# Booster Section of Interstage Coupler

SIZE <b>A</b>	FSCM NO.	DWG NO. Mass = 2.18 kg CG = 3.93" from top (4.23" from ref.)	REV
SCALE	B. Feretich & G.Saviers	SHEET

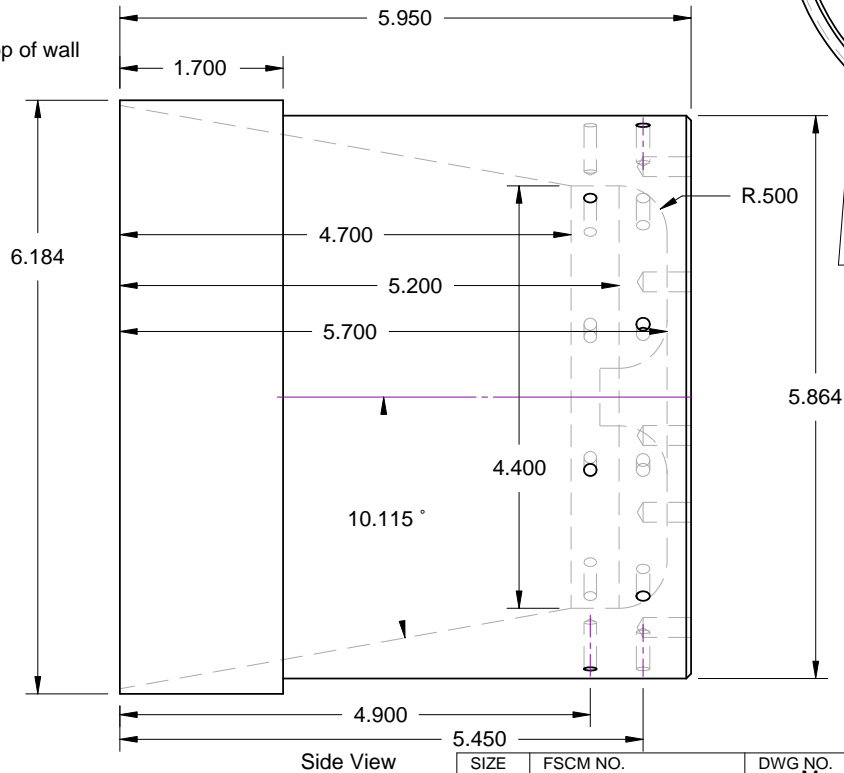
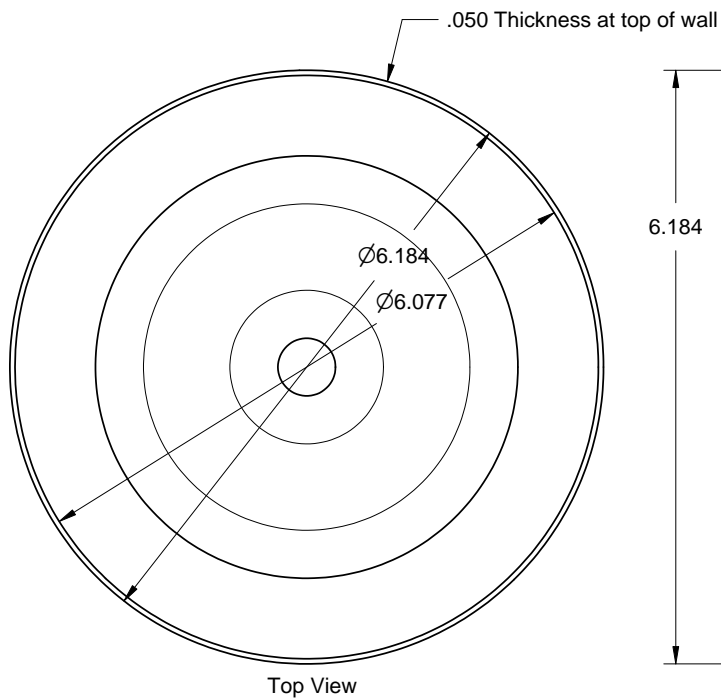
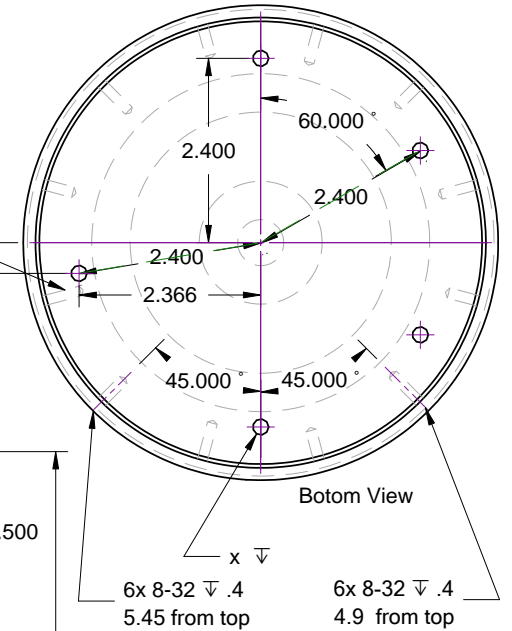
Note clearance issue. This hole must be part of the 4.9 ring.
